Access Compliance Report

Public Rights-of-Way

(Curb Ramps)

Intersection ID: 10034961	Main Street: PROVIDENCE_RD_WEST	Cross Street: N/A	Location: SW
ADA ID: F876526C9DE5	Ramp Type: PerpDiag	Initial Pass/Fail: Fail	Overall Compliance: No
Codes/Mitigation Info/Possible Solution		Field Measurements/Component Compliance	
Severity Score: 22.5

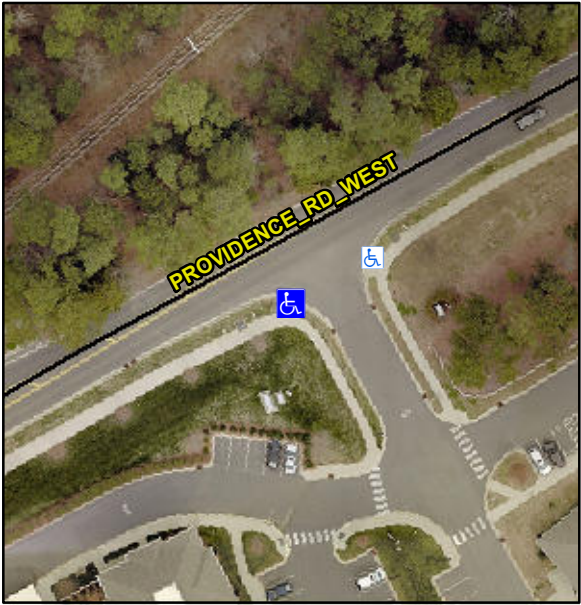
Possible Solutions:						
	Remove & Replace Curb Ramp With Two New Directional Ramps or Equivalent.	Compliance	Description	Data	Compliance	Description	Data
		N/A	Ramp Length (in)	64.0	No	Ramp Slope (%)	8.6
		No	Ramp Width (in)	47.0	No	Ramp XSlope (%)	4.1
		N/A	Flare Type LT	N/A	N/A	Flare Type RT	N/A
		N/A	Flare Slope LT (%)	N/A	N/A	Flare Slope RT (%)	N/A
		N/A	Flare Traversable LT?	N/A	N/A	Flare Traversable RT?	N/A
		N/A	Landing Length (in)	N/A	N/A	DWS Provided?	N/A
		N/A	Landing Width (in)	N/A	N/A	DWS Contrast?	N/A
		N/A	Landing Slope (%)	N/A	N/A	DWS Length (in)	N/A
<p>Surveyor Notes:</p> <p>N/A</p> <p>PROW/ADA:</p> <p>Not Found, R304.5.1, R304.2.2, R304.5.3</p>		N/A	Landing X Slope (%)	N/A	N/A	DWS Full Width?	N/A
		N/A	Landing Curb? (Y/N)	N/A	N/A	DWS Offset (in)	N/A
		N/A	Shared Landing?	N/A			
		N/A	Gutter Ponding?	N/A	N/A	Gutter Slope (%)	N/A
		N/A	Gutter Lip Ht (in)	N/A	N/A	Gutter X Slope (%)	N/A
